**GM SERVICE AND PARTS OPERATIONS
DCS1764
URGENT - DISTRIBUTE IMMEDIATELY**

Subject: 06217A – Noncompliance Recall
Head Impact Protection
Service Procedure and Claim Information Revised

Models: 2005-2006 Chevrolet Cobalt Coupe
Without Roof-Mounted Side Impact Airbags

FMVSS NONCOMPLIANCE RECALL

1883691

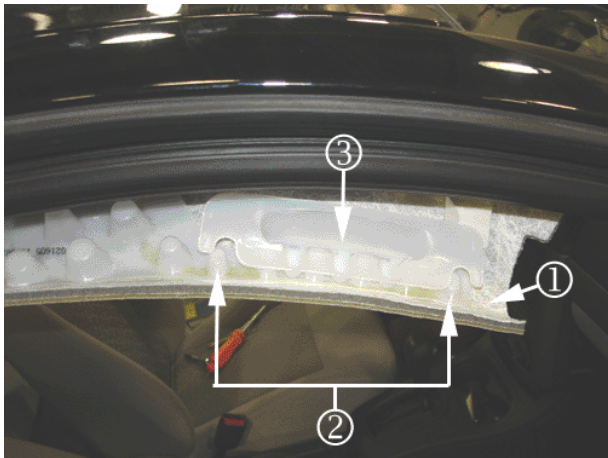
Current Production and Service Repair

- If the vehicle does **not** have side impact air bags, refer to the service procedure in this bulletin. Perform steps 1-4 on the driver's side of the vehicle only. After performing steps 1-4, the headliner will drop about 203 mm (8 in), which will provide adequate room to determine if the energy absorbing (EA) piece has been installed.

- If either the interim production or current production/service repair have been performed, re-install the headliner, A-pillar trim panel, and sunshade. Submit a claim for *Inspect Vehicle to Determine if Energy Absorbing Device is Installed*, labor operation V1594 for 0.4.

- If the production repair has **not** been performed, complete the service procedure in this bulletin. Install the energy absorbing (EA) plastic piece into the headliner at both the driver and passenger side A-pillar locations. Submit a claim for *Install Energy Absorbing Device*, labor operation V1556 for 0.7.

1883691

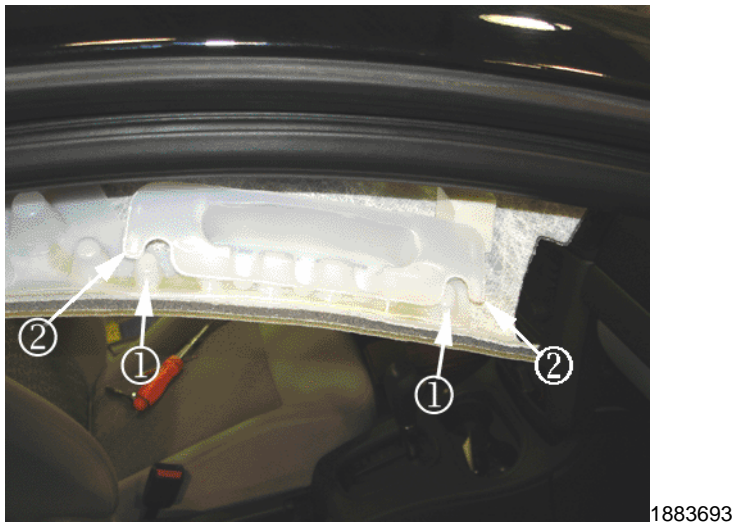
Important: The headliner will drop about 203 mm (8 in), which will provide adequate room to install the insert energy absorbing (EA) plastic piece into the headliner. Use GM Care Hot Melt Adhesive Sticks (P/N 12377914) or equivalent to glue the EA plastic piece into the headliner.

5. Locate the installation anchor points (2) for installing the energy absorbing (EA) plastic piece (3) onto the headliner (1).
